UNITED STATES PATENT AND TRADEMARK OFFICE

Office Action Summary	Application No. 10/537,424	Applicant(s) JONES ET AL.	
	Examiner CANDACE L. BRADFORD	Art Unit 3634

DETAILED ACTION

**FIG. 3a**

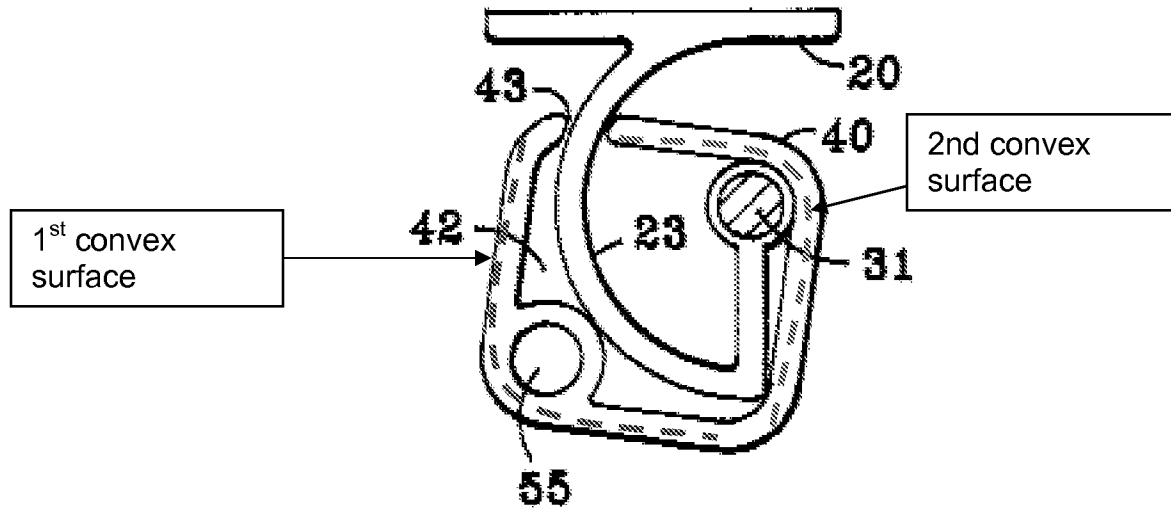
Claim 21 is rejected under 35 U.S.C. 102(b) as being anticipated by Noles (5979599). Noles discloses a body 40, which defines an internal passageway 42, and a slot 43, said internal passageway extending longitudinally through said body and configured to receive the safety line 31, said slot extending through said body to said internal passageway in a transverse direction relative to said internal passageway, said slot configured to allow a portion of a given support 20, coupled to the safety line to pass through said slot when said traveler traverses said given support along the safety line, said body including a load member 55, for attaching said traveler to fall safety equipment, and first and second gates spaced apart from one another and defining said slot therebetween, wherein said first gate is disposed below said second gate when said body is disposed vertically about the safety line, as best seen in Figure 3b and 3c, and wherein an upper portion of said body is rotatable about the longitudinal centerline of the safety line away from the given support to a predetermined first rotational orientation in which a portion of said first gate interfaces to said given support to limit further angular movement of said upper portion of said body away from said given support, as best seen in Figure 3c.

Claim 23 is rejected under 35 U.S.C. 102(b) as being anticipated by Noles (5979599). Noles discloses said first gate has a first convex surface, said second gate

other and define said slot 43.

FIG. 3a

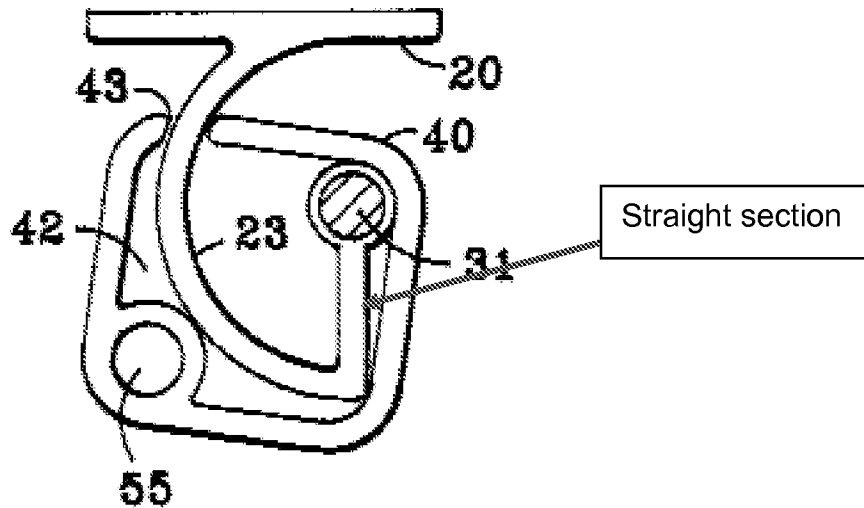
Claim 22 is rejected under 35 U.S.C. 102(b) as being anticipated by Noles (5979599). Noles discloses said upper portion of said body is rotatable to a predetermined second rotational orientation in which a portion of said second gate interfaces to said given support to limit further angular movement of said upper portion of said body toward said given support, as best seen in Figure 3a.

Claim 29 is rejected under 35 U.S.C. 102(b) as being anticipated by Noles (5979599). Noles discloses said portion 23, of said given support is narrower than said slot 43, as best seen in Figure 3a.

Claim 33 is rejected under 35 U.S.C. 102(b) as being anticipated by Noles (5979599). Noles discloses said first gate has a first convex surface, said second gate has a second convex surface, and said first and second convex surfaces face each other and define said slot, as best seen in the marked-up figure above.
